RENESAS TECHNICAL NEWS

No.ASSP-08-0309

M66291 Dreq Signal Assertion Limitation

USB ASSP M66291GP/M66291HP

Figure 1. Incorrect Signal at Dreq Signal Assert

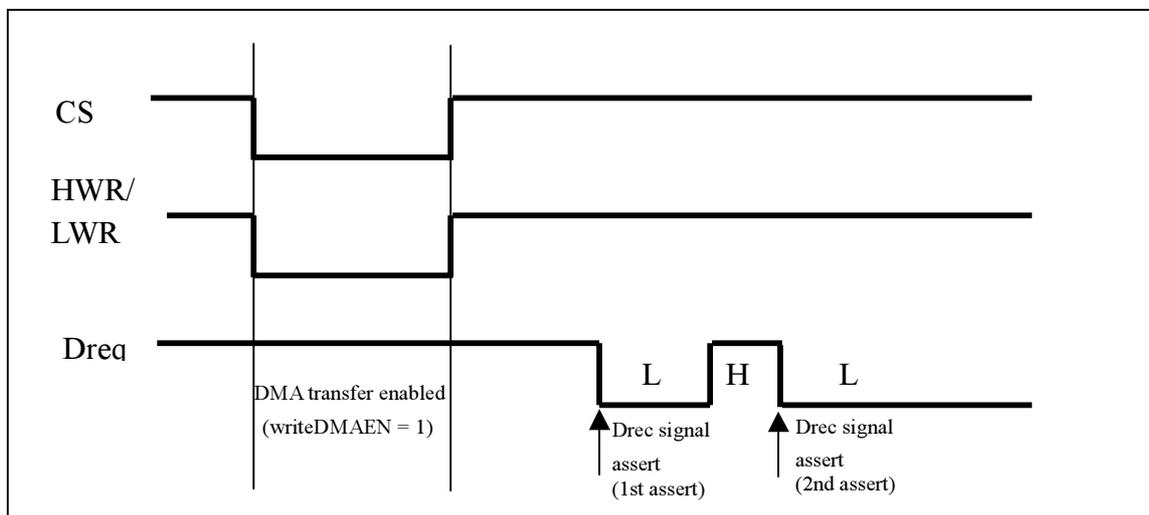
In systems that send DMA transfers to the IN-direction endpoint using D0_FIFO or D1_FIFO (Dn_FIFO hereon) by the DMA controller, when DMA transfer is enabled (write DMAEN = "1"), the Dreq signal may be asserted twice consecutively (see Diagram 1).

[Supplement] If the system is set so that the DMA transfer is triggered by the M66291 Dreq signal, this phenomenon may cause the DMA controller to malfunction, and data will not be written successfully to the Dn_FIFO.

- (1) Simultaneous Setup Method for DMA transfer enable and endpoint designation
To enable DMA transfer (write DMAEN = "1"), perform the following processes in the order indicated.
 - a. The CPU writes to the Dn_FIFO Select Register in word units when DMA transfer is disabled (write DMAEN = "0") and the endpoint is cleared (DMA_EP = "0000")
 - b. The CPU writes to the Dn_FIFO Select Register in word units when DMA transfer is enabled (write DMAEN = "1") and the endpoint is set (DMA_EP = corresponding EP)

- (2) CPU Byte-Unit Write Method

When enabling DMA transfer (write DMAEN = "1"), perform a write in byte-units to the upper 8 bits of the Dn_FIFO Select Register.

- * Do not write to the lower 8 bits of the Dn_FIFO.
- * The designated endpoint (DMA_EP = corresponding EP) must be set before writing to the upper 8 bits.
